Project No. 24-010.00

March 17, 2025

ADDENDUM NO. 3
TO THE
DRAWINGS AND PROJECT MANUAL
FOR
**COOK-LABAY-TRUITT MS RENOVATIONS
CYPRESS-FAIRBANKS INDEPENDENT SCHOOL DISTRICT
HOUSTON, TEXAS**

A17.01

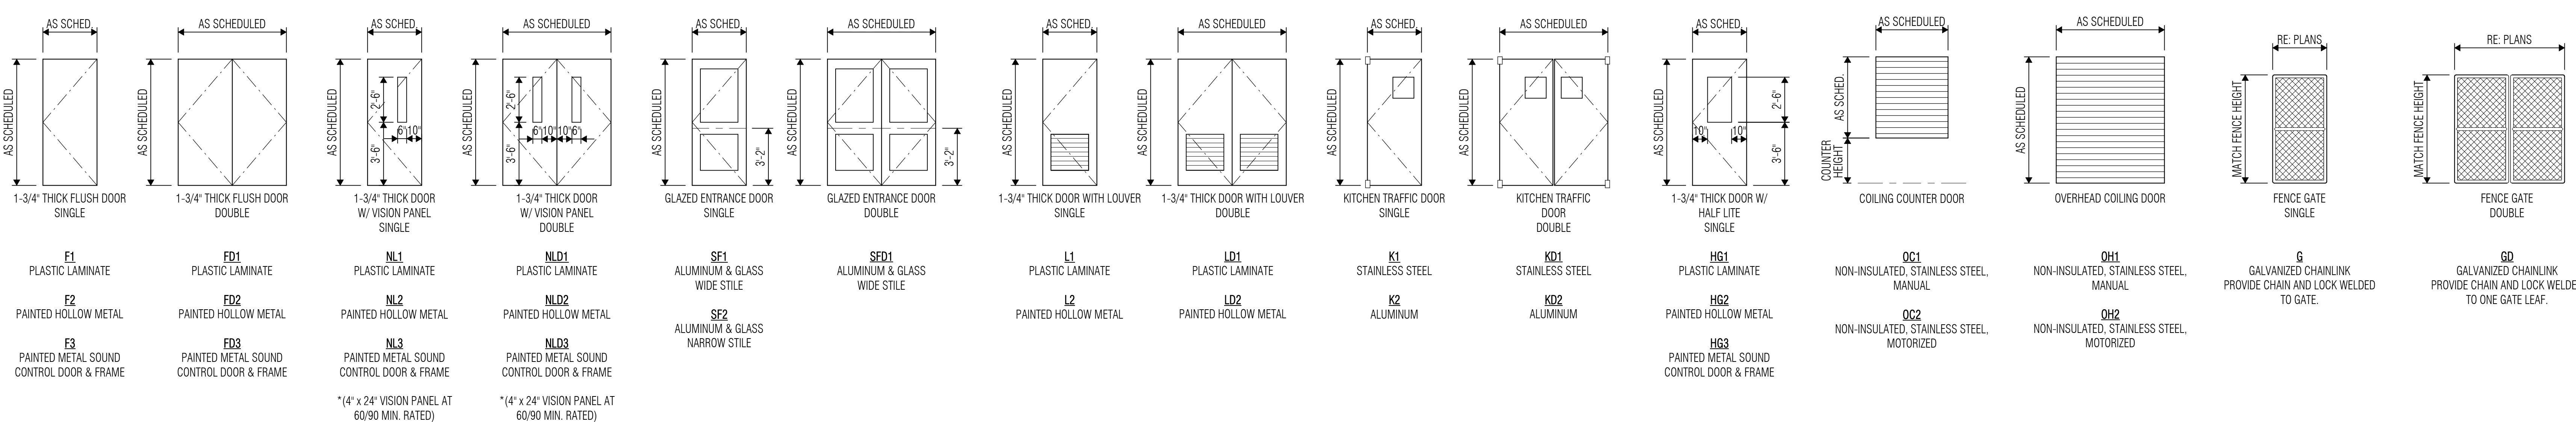
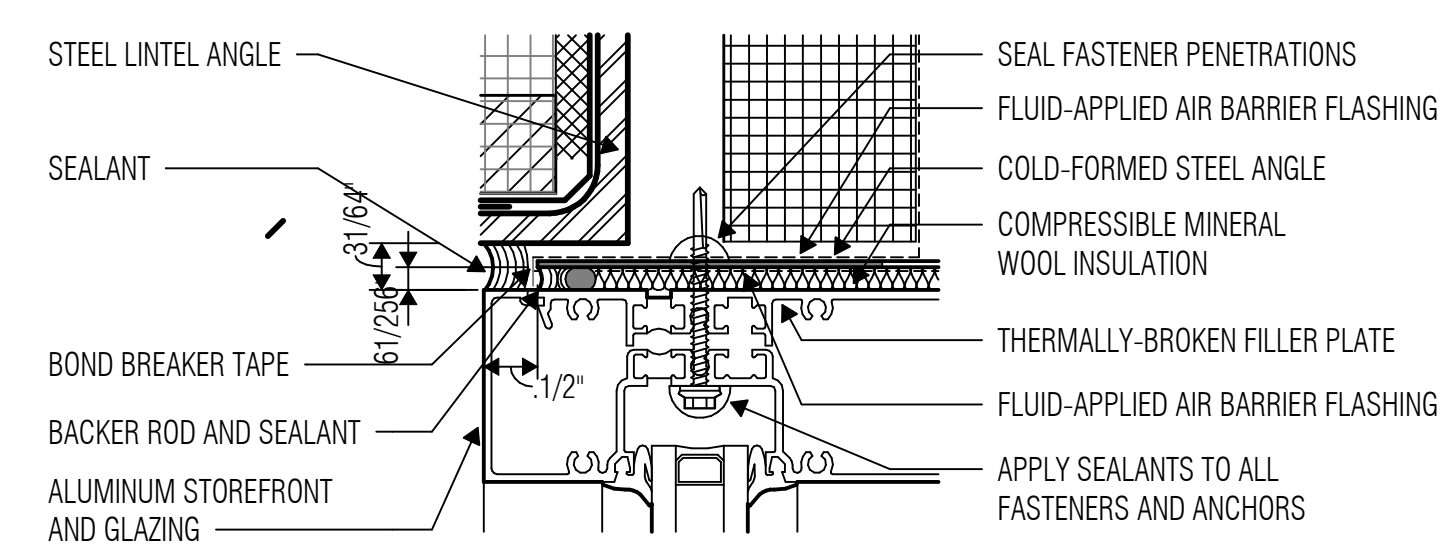
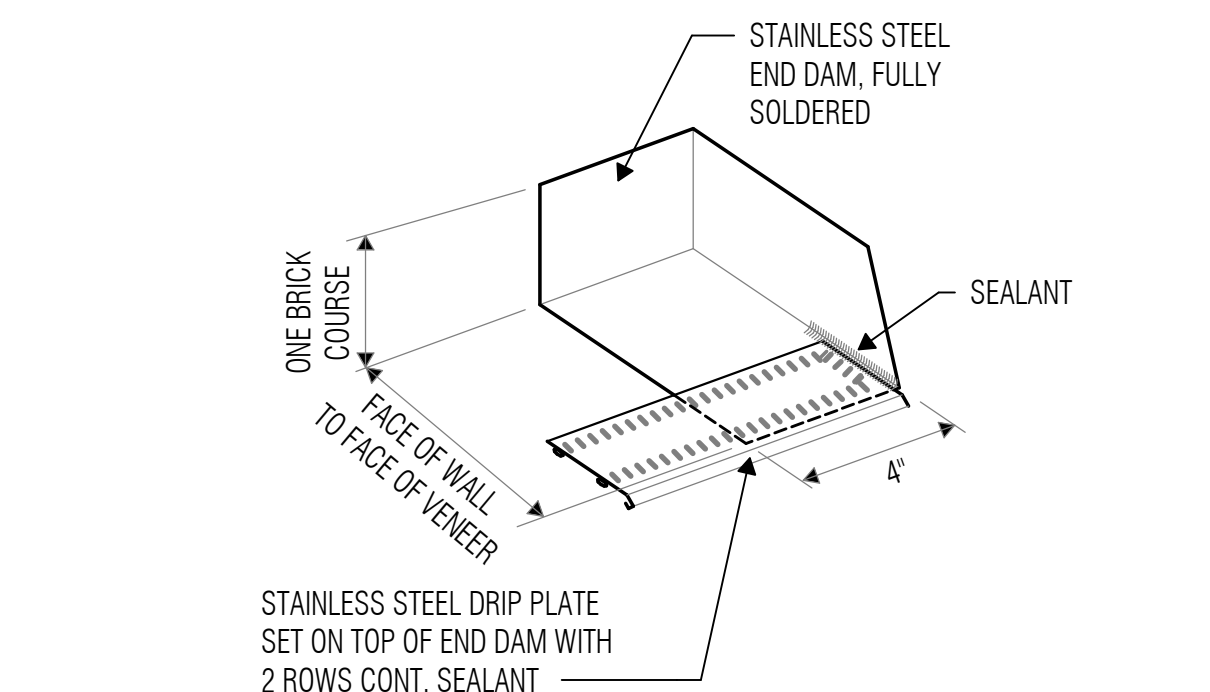
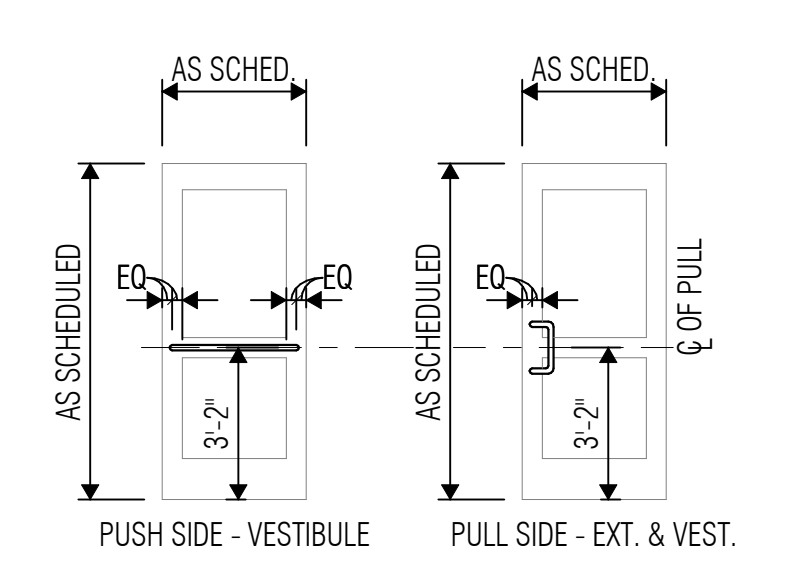
- A. Sheet Nos. A17.01, A27.01, and A37.01, dated March 17, 2025 and attached hereto, are revised drawings and are hereby made a part of this addendum.
